Chefornak Washeteria as of 9/24/12

Request for Information (RFI)/  
Design Clarification/Variation Request (DCVR)

Project Name:	City of Chefnak Provisional Washeteria		
Date:	12/10/10	Response Need Date:	12/21/10
RFI#:	RFI-	DCVR#:	DCVR-3
Submitted to:	Lloyd Persson		
From (Company):	CE2 Engineers		
By:	Chad Mountcastle

# CHEFORNAK PROVISIONAL WASTEWATERIA FORCE MAIN w/ GLYCOL HEAT TRACE

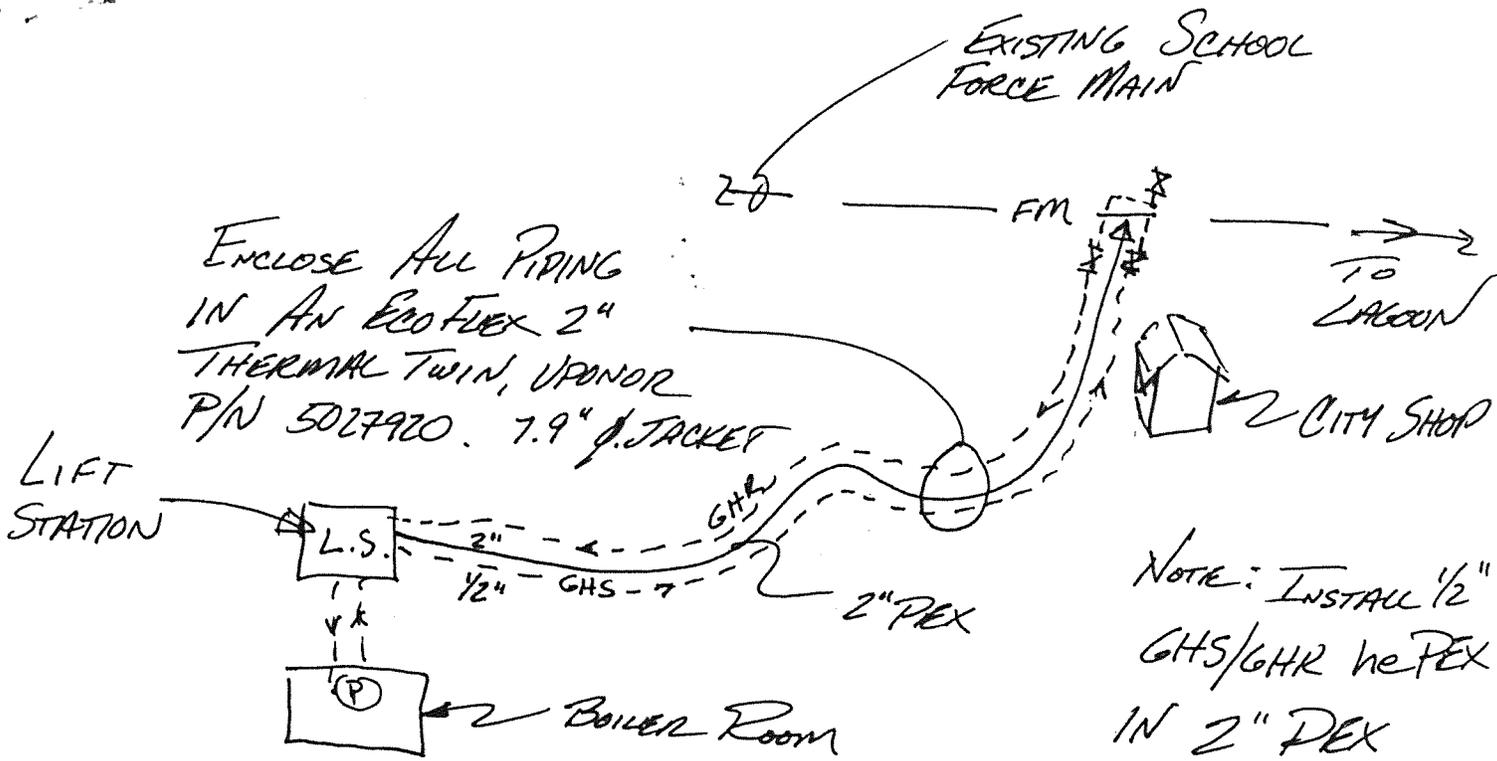
We are unable to install the force main in the plan location because of a new materials staging area constructed by the school contractor.

Since we are not certain when the materials staging area will be "available," convert the design to a 2" flexible arctic force main with glycol heat trace as shown on the attached sketch. Adjust the alignment to the north near the city shop and avoid the school materials. Place a 12" dia culvert under the road and to allow the flexible force main (8" OD) to be easily installed and/or relocated in the future if necessary with minimal down time of the washeteria.
